These changes are based on the proposed changes to First Street based on the Town of Prosper's request.

The attached revised sheets (7, 62, 71, 78, 106A, 106B, 114A, 114B, 122, 221, 250A, 250B, 250C, 288, 289, 290, 291, 299, 302, 303, 337) for the First Street Improvements at the SBFR should be issued with this change order #4.

The net increase (decrease) to the Dallas North Tollway Southbound Frontage Road project cost by this Change Order is **\$666,418.47**.

1	3/27/2019	First St Revisions	MML
NO.	DATE	REVISION	APPROV.
DALLAS NORTH TOLLWAY SBFR			
PROPOSED TYPICAL SECTIONS			
4 OF 5			
HALFF			
<small>3803 PARKWOOD BLVD, SUITE 800 FRISCO, TEXAS 75034-8641 TEL (214) 618-4570 FAX (214) 618-4574 FIRM REGISTRATION NO. 312</small>			
DRAWN	MML	DATE 7/13/2016	DESIGNED EEM DATE 7/13/2016
CHECKED	MML	DATE 4/10/2018	SCALE NTS
CONTRACT NO. 03787-DNT-03-CN-PM SHEET 7 OF 343

CULVERT LAYOUT
CULVERT W4

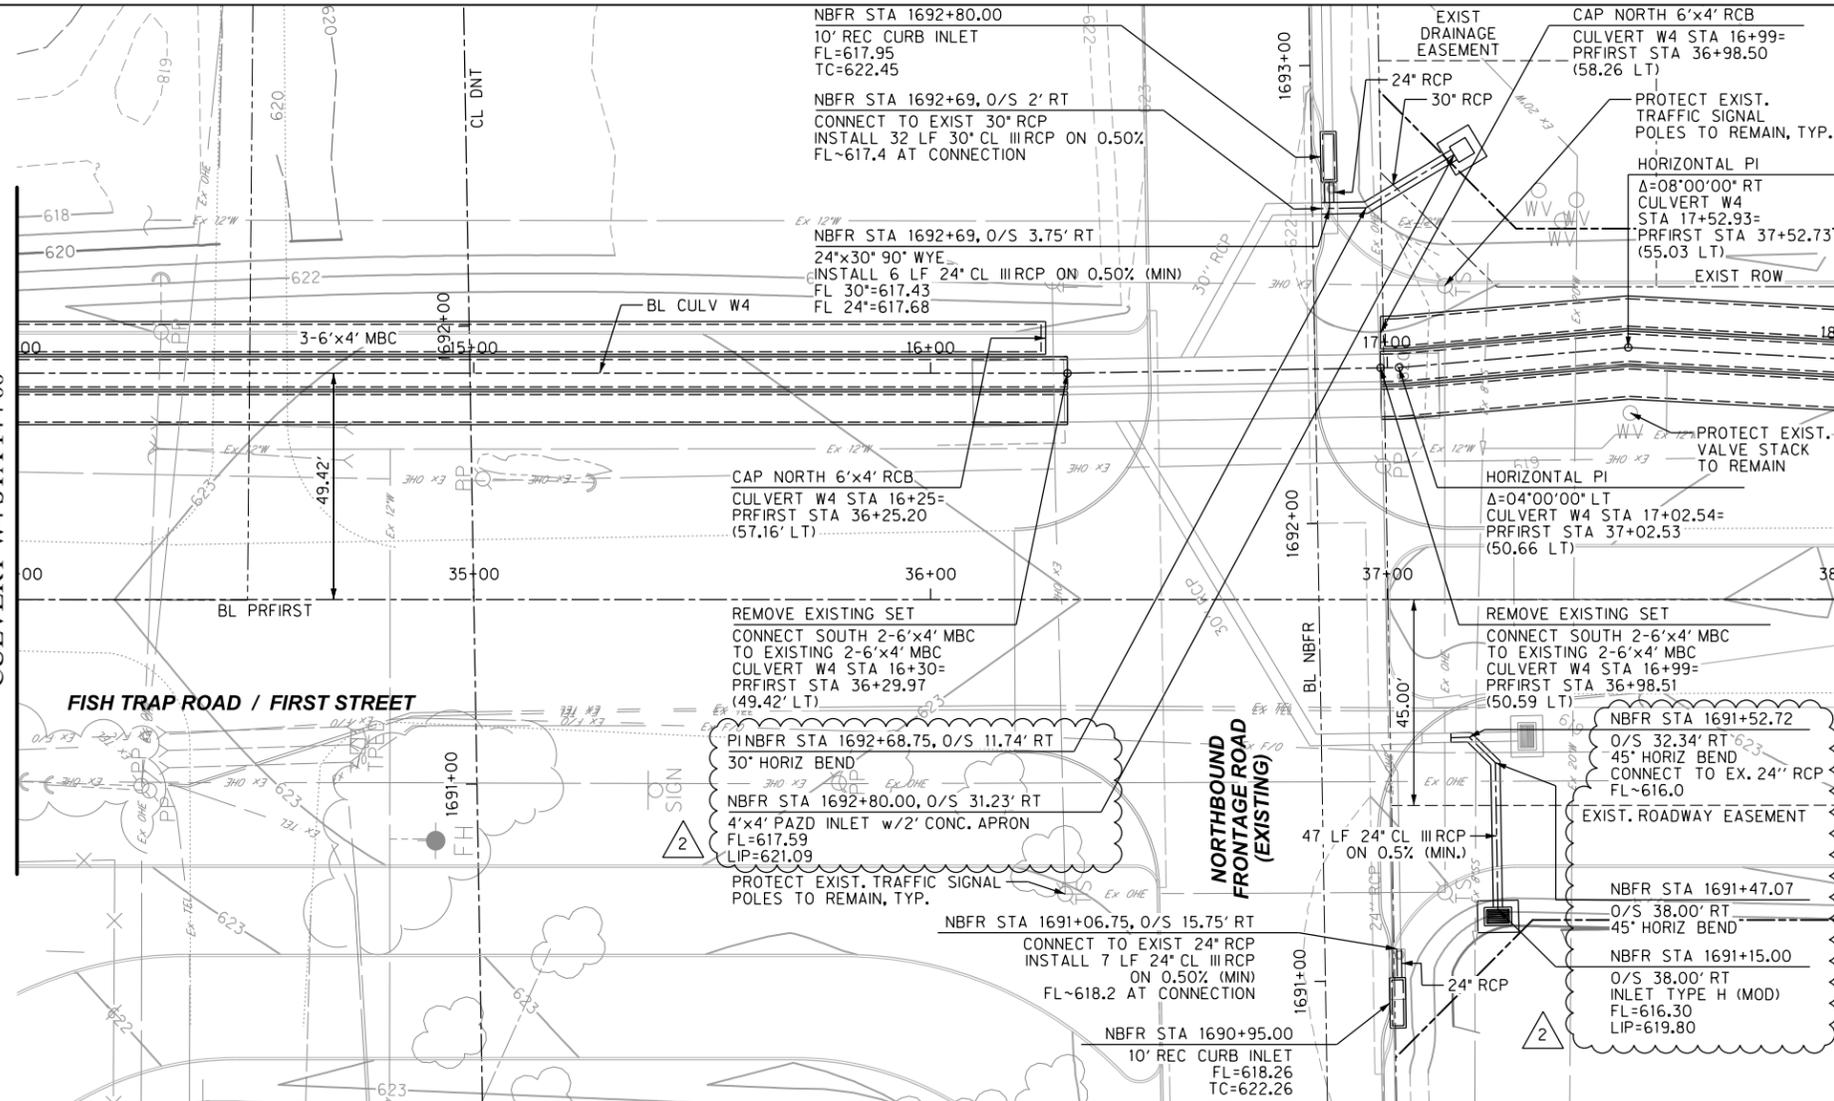
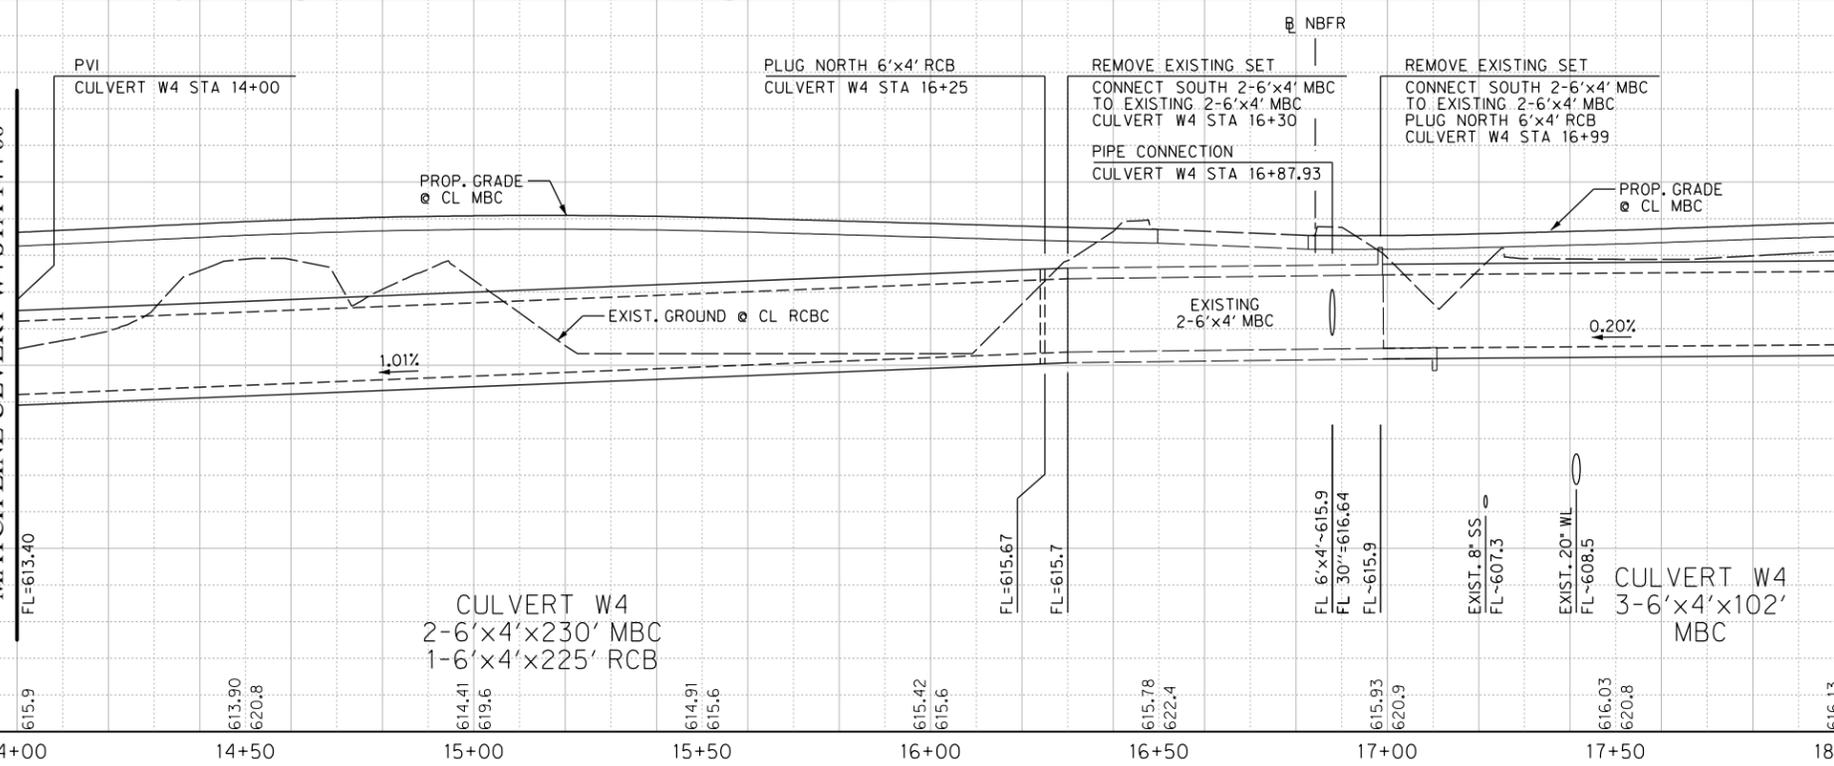
2	3/27/2019	Revised Inlet Layouts	DDS
1	9/4/2018	Sheet Added, Replaces Sheet 250	DDS
NO.	DATE	REVISION	APPROV.

CONTRACT NO. 03787-DNT-03-CN-PM SHEET 250B OF 343

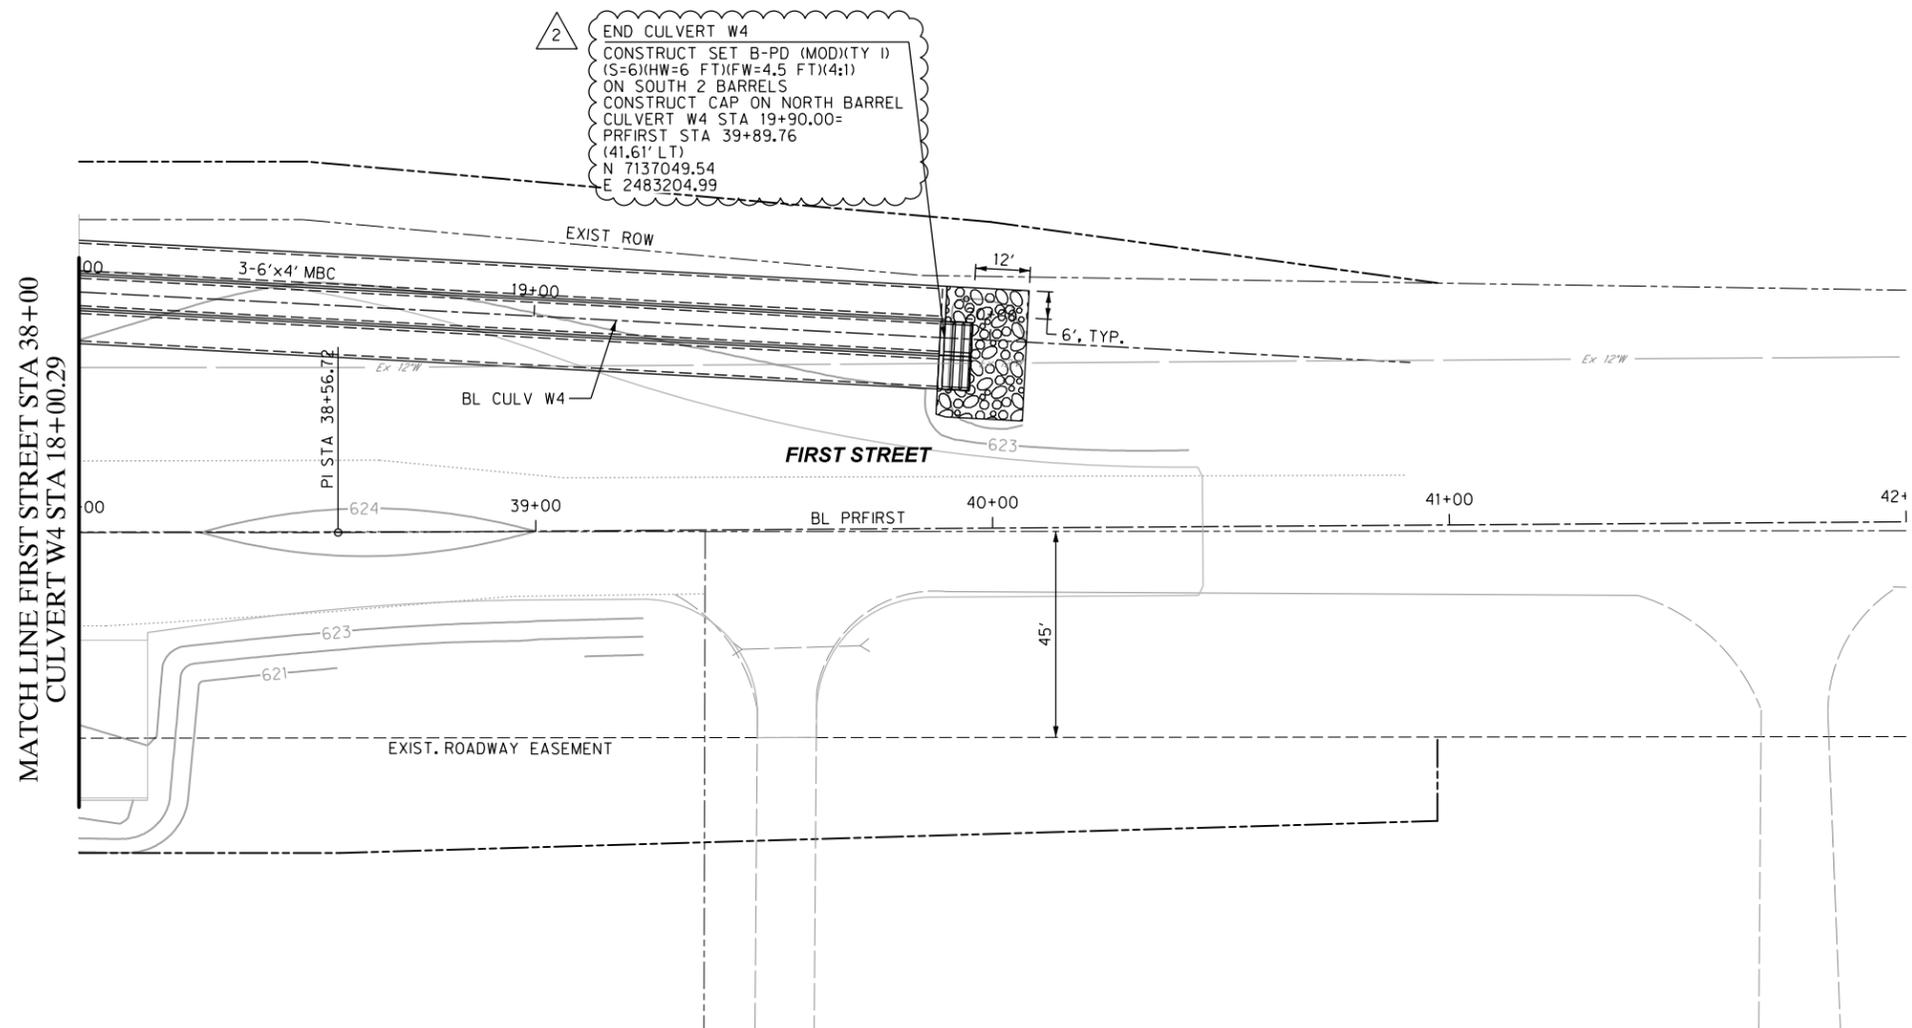
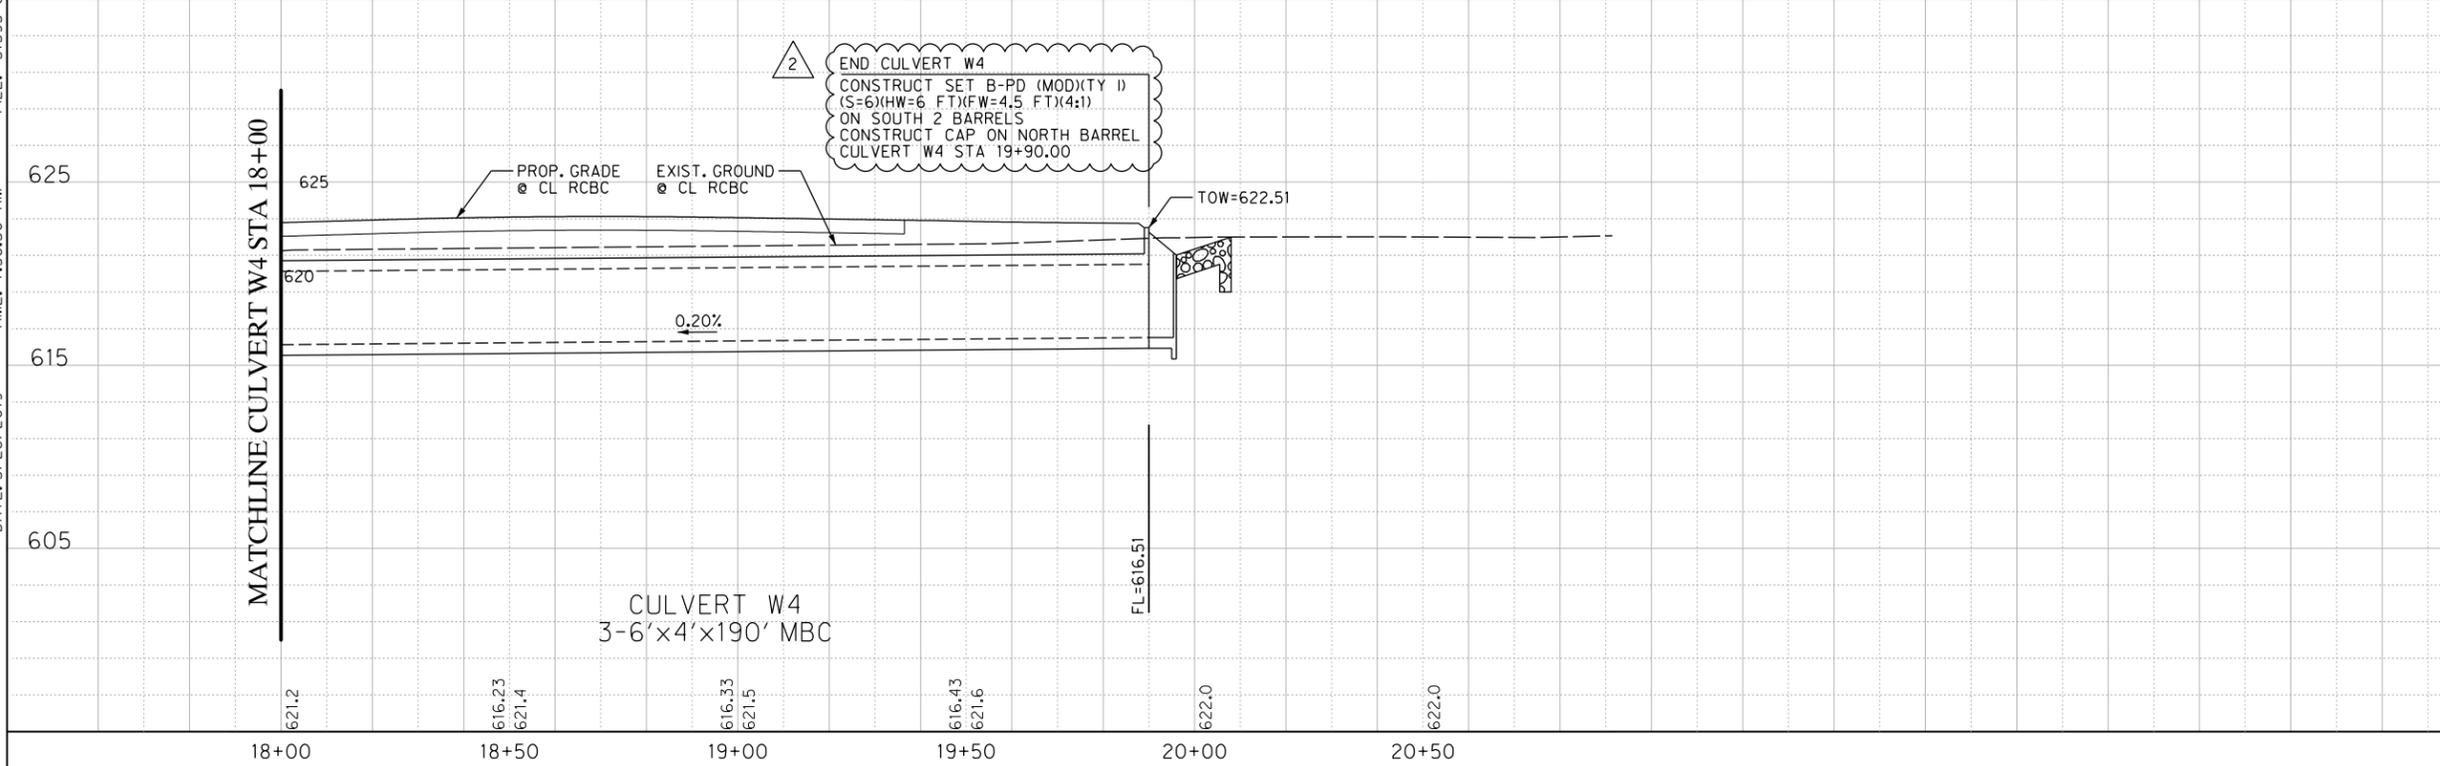
2	3/27/2019	Revised SET	DDS
1	9/4/2018	Sheet Added, Replaces Sheet 250	DDS
NO.	DATE	REVISION	APPROV.
